October 31, 1994

DOCKETS 50-266 AND 50-301
RESPONSE TO THE REQUEST FOR ADDITIONAL INFORMATION REGARDING
REQUEST FOR EXEMPTION FROM THE REQUIREMENTS OF SECTION III.G OF
APPENDIX R TO 10 CFR 50 FOR THE AUXILIARY FEEDWATER PUMP ROOM
POINT BEACH NUCLEAR PLANT, UNITS 1 AND 2

ATTACHMENT 1
RESPONSE TO THE REQUEST FOR ADDITIONAL INFORMATION
APPENDIX R EXEMPTION REQUEST

Figure 1.0
D01-2 Conduit Raceway in Auxiliary Feed Water Pump Room

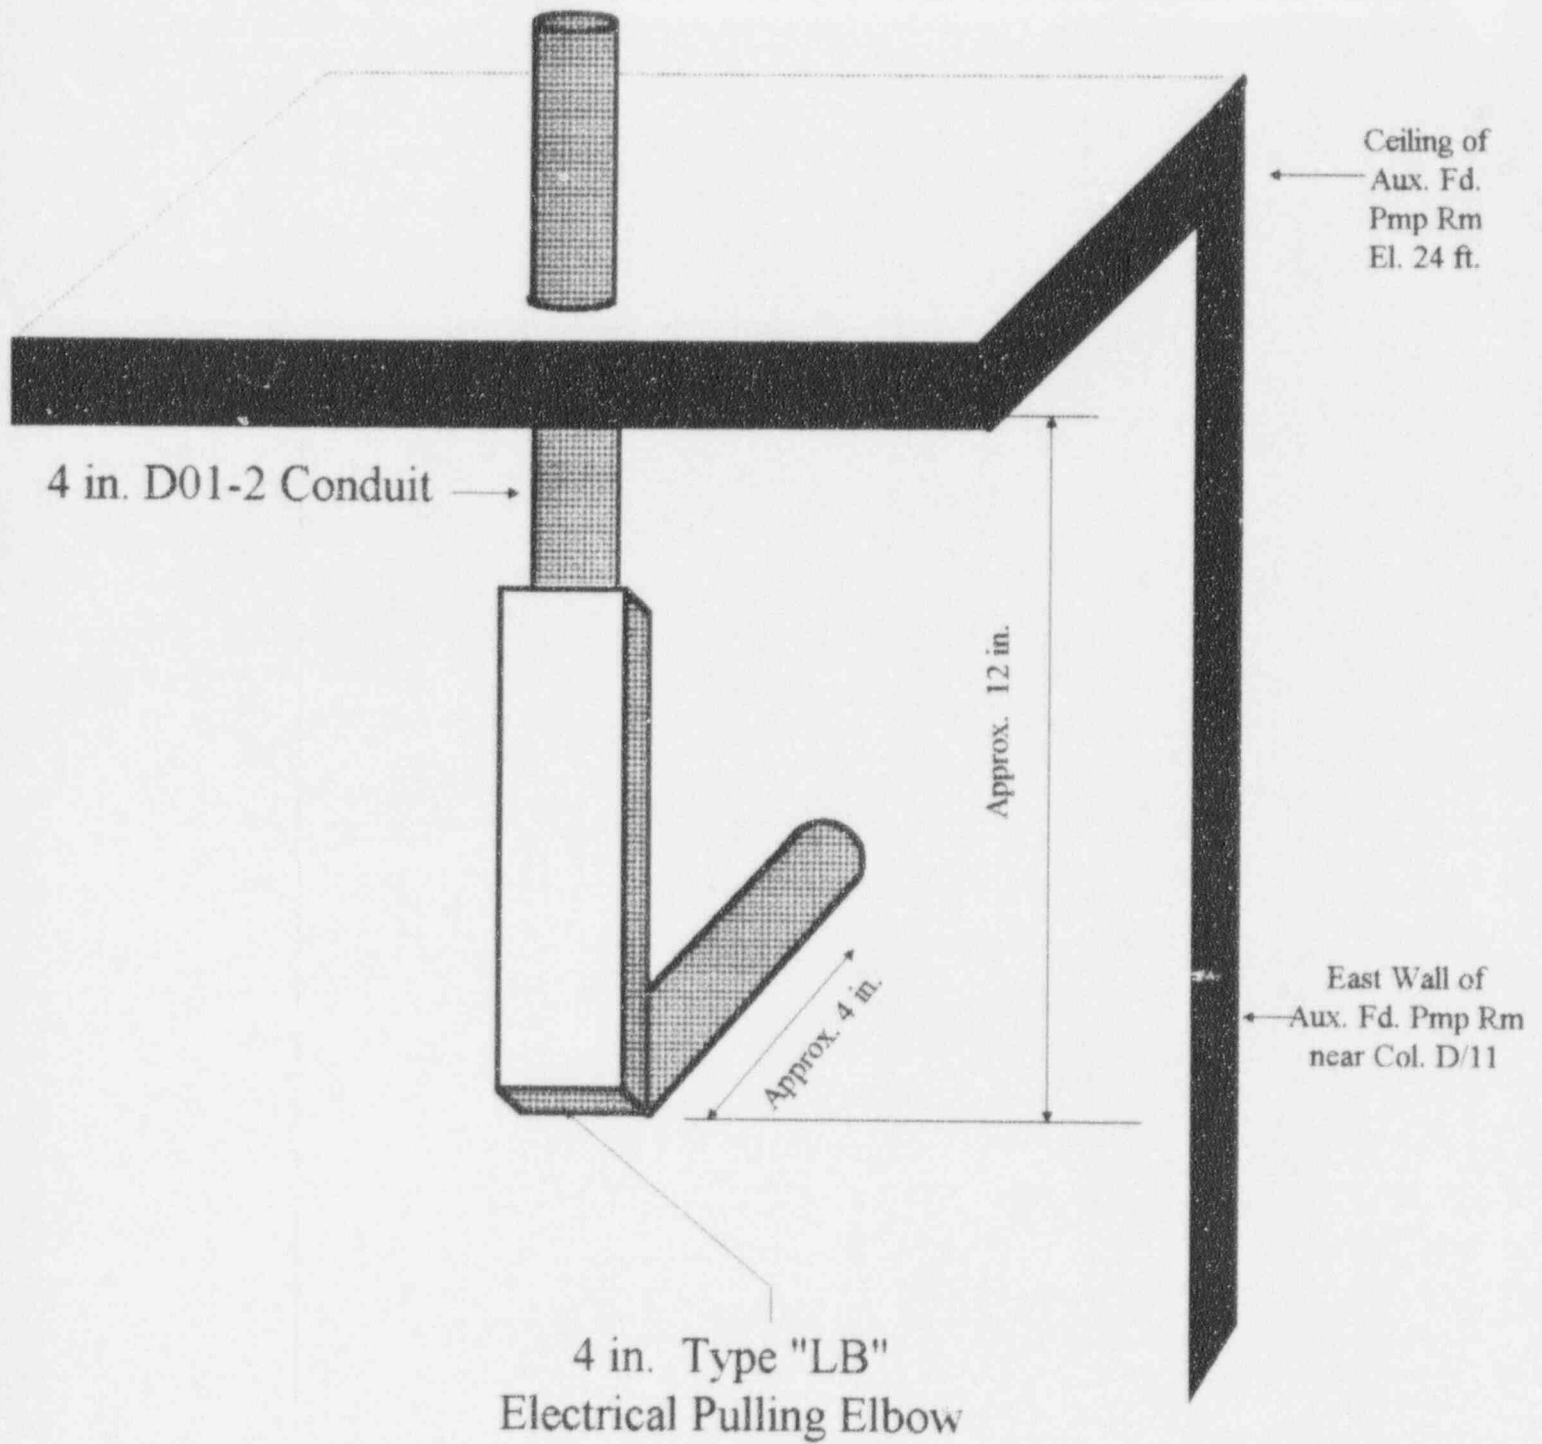
13.0 In a letter dated October 13, 1994, the NRC requested additional information regarding our proposed fire protection for Conduit D01-2. This request states:

"You stated that Conduit D01-2 would be wrapped with the E-50 series fire barrier material, manufactured by 3M Corporation, to provide a 1-hour rating to ensure that the conduit is protected from a fire in the fire area. Please provide the fire endurance test reports, and any other supporting documentation used to qualify this configuration as a 1-hour rated fire barrier."

In preparation for our submittal of the August 5, 1994 exemption request, we determined that a short section of Conduit D01-2 was located in the 20-foot separation area between the FU and FR cable trays in the auxiliary feedwater pump room. This short section of conduit is the only portion of the 125 VDC red instrumentation channel that could potentially be affected by certain fire scenarios in the room. We determined that we could provide additional flexibility in the 125 VDC distribution in this room simply by protecting this short section of conduit. The additional flexibility provided by protecting the D01-2 conduit is shown in the Instrumentation Options Matrix in Attachment 5.

system is already installed on several conduit located in the auxiliary feedwater pump room. The configuration and specific details about Conduit D01-2 are included in Attachment 9. The location of D01-2 with respect to other cable trays in the room is shown on Attachments 3 and 4.

Conduit D01-2 is a 4-inch diameter conduit that enters through the east wall of the auxiliary feedwater pump room approximately four inches and then turns upward for approximately twelve inches, exiting the room through the ceiling. A detailed design of the fire barrier system for this conduit has not been completed; however, preliminary design has been completed with the assistance of 3M Corporation. This design consists of a 1-hour, fire-rated assembly using E-53 or E-54 fire barrier mat from 3M Corporation. The mat would be arranged to enclose the conduit into the corner of the wall and ceiling in the room using 3M-approved installation details 5500-C7-2 and 6100-E1. Both details are provided in Attachment 9. The proposed assembly will be installed, as per the installation details, by contractors trained in the use and application of these systems.
